NEW MEXICO OIL CONSERVATION DIVISION

ADMINISTRATIVE APPLICATION CHECKLIST

WELL NAME & NUMBER: Harroun 15 #3

From: Jones, William V., EMNRD
Sent: Wednesday, April 18, 2012 5:15 PM
To: 'David_Stewart@oxy.com'
Cc: Ezeanyim, Richard, EMNRD; Shapard, Craig, EMNRD; 'Wesley_Ingram@blm.gov'; 'Slack, Ronnie'
Subject: Disposal application from OXY: Harroun 15 #3 API 30-015-29233 Bell Canyon from 3041 to 3765 feet.

OXY USA Inc. - Proposed
Harroun 15 #3
API No. 30-015-29233

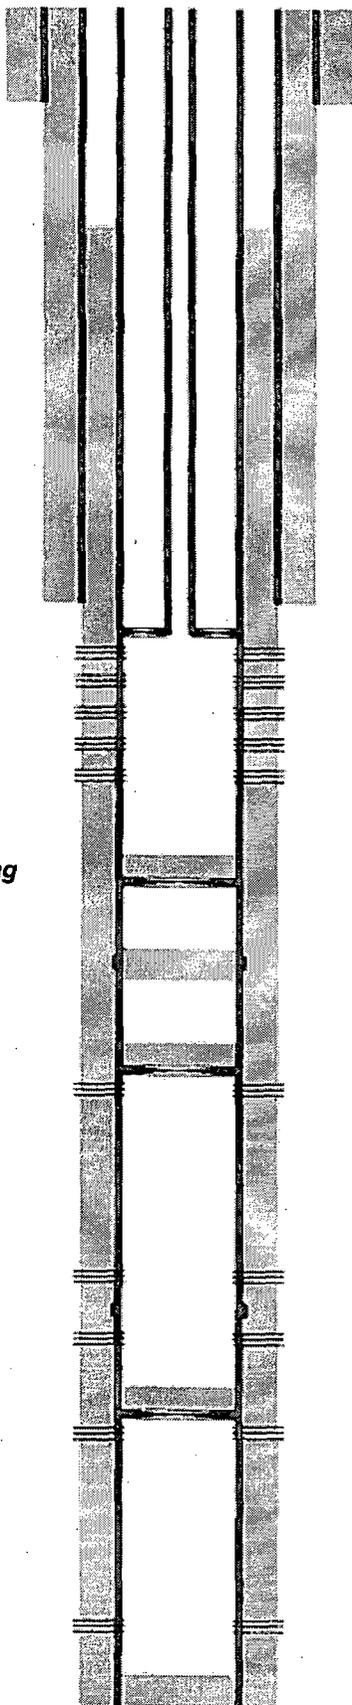
- a. Sent another Post Conversion wellbore diagram showing the revised proposed perforations and also showing an installed CIBP/cement within 200 feet below the disposal interval.
- b. Please send a wellbore diagram for Devon's 30-015-29915 showing the "calced" cement top and open annulus issues. Tell us what assumptions were used to calc the cement top and whether you anticipate any bradenhead issues.

- a. Sent another Post Conversion wellbore diagram showing the revised proposed perforations and also showing an installed CIBP/cement within 200 feet below the disposal interval.
- b. Please send a wellbore diagram for Devon's 30-015-29915 showing the "calced" cement top and open annulus issues. Tell us what assumptions were used to calc the cement top and whether you anticipate any bradenhead issues.

CIBP @ 4065' w/ 15sx cmt to 3965' WOC-Tag

25sx @ 4600-4400' WOC-Tag

Please review the attached procedure and let me know if it is OK. It is basically what was originally filed, I just added the plugs and removed the proposed lower perms, which eliminate 2 stages.

Item X - Harroun 15 #3 - 30-015-29233

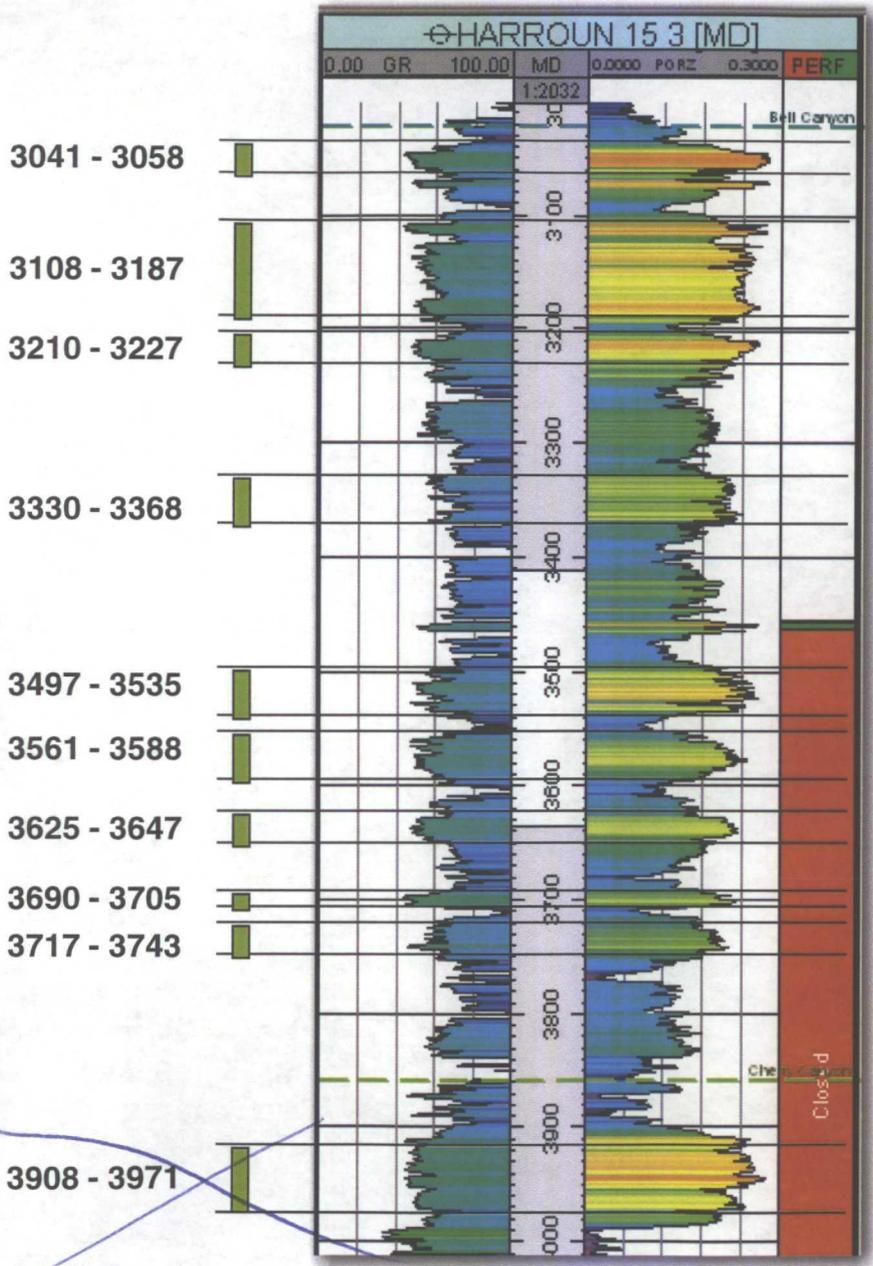
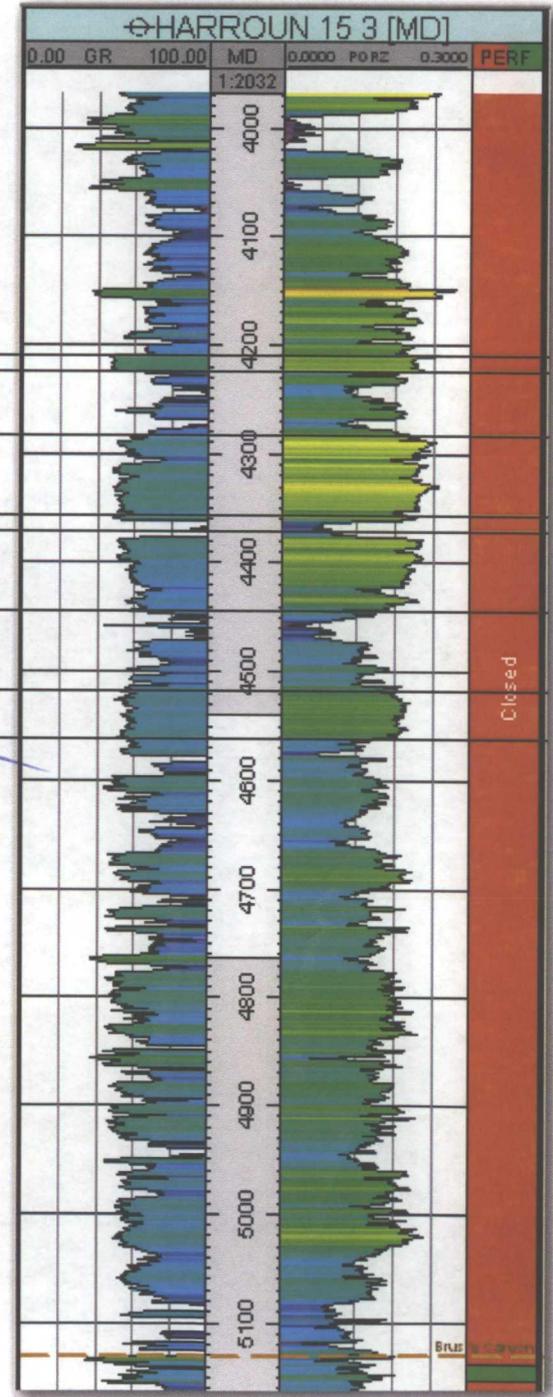
~~4207 - 4226~~

~~4289 - 4361~~

~~4378 - 4440~~

~~4518 - 4560~~
